Access Compliance Report

Public Rights-of-Way

(Curb Ramps)

Intersection ID: 47696	Main Street: LEES_COURT_ST	Cross Street: WHITBY_LN	Location: E
ADA ID: 142D5E632942	Ramp Type: PerpDiag	Initial Pass/Fail: Fail	Overall Compliance: No
Codes/Mitigation Info/Possible Solution		Field Measurements/Component Compliance

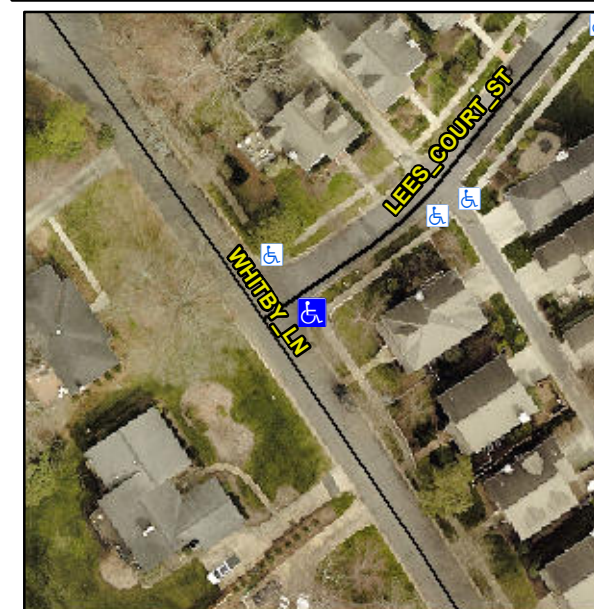
Not Found, R304.5.1, R304.2.2, R304.5.3

Compliance	Description	Data	Compliance	Description	Data
N/A	Ramp Length (in)	71.0	No	Ramp Slope (%)	8.5
No	Ramp Width (in)	45.0	No	Ramp XSlope (%)	7.4
N/A	Flare Type LT	N/A	N/A	Flare Type RT	N/A
N/A	Flare Slope LT (%)	N/A	N/A	Flare Slope RT (%)	N/A
N/A	Flare Traversable LT?	N/A	N/A	Flare Traversable RT?	N/A
N/A	Landing Length (in)	N/A	N/A	DWS Provided?	N/A
N/A	Landing Width (in)	N/A	N/A	DWS Contrast?	N/A
N/A	Landing Slope (%)	N/A	N/A	DWS Length (in)	N/A
N/A	Landing X Slope (%)	N/A	N/A	DWS Full Width?	N/A
N/A	Landing Curb? (Y/N)	N/A	N/A	DWS Offset (in)	N/A
N/A	Shared Landing?	N/A			
N/A	Gutter Ponding?	N/A	N/A	Gutter Slope (%)	N/A
N/A	Gutter Lip Ht (in)	N/A	N/A	Gutter X Slope (%)	N/A
N/A	Painted X Walk1?	No	N/A	Painted X Walk2?	No
	X Walk 1 Direction	To NE		X Walk 2 Direction	To W
N/A	X Walk 1 Width (in)	N/A	N/A	X Walk 2 Width (in)	N/A
	X Walk 1 Slope (%)	2.8		X Walk 2 Slope (%)	6.9
	X Walk 1 X Slope (%)	5.5		X Walk 2 X Slope (%)	0.4

N/A	Ramp inside XWalk1?	N/A	N/A	Ramp inside XWalk2?	N/A
	Road Slope (%)	3.9	N/A	Clear Space?	N/A
	Road X Slope (%)	5.7	N/A	Clear Space to XWalk (in)	N/A
N/A	Any Obstructions?	N/A	N/A	Storm Grate/Utility Hazard?	N/A
	Obstruction Type			Storm Grate/Utility Type	
		N/A			N/A
			Yes	Surface Condition? (G/P)	Good

Remove & Replace Curb Ramp With Two New Directional Ramps or Equivalent.
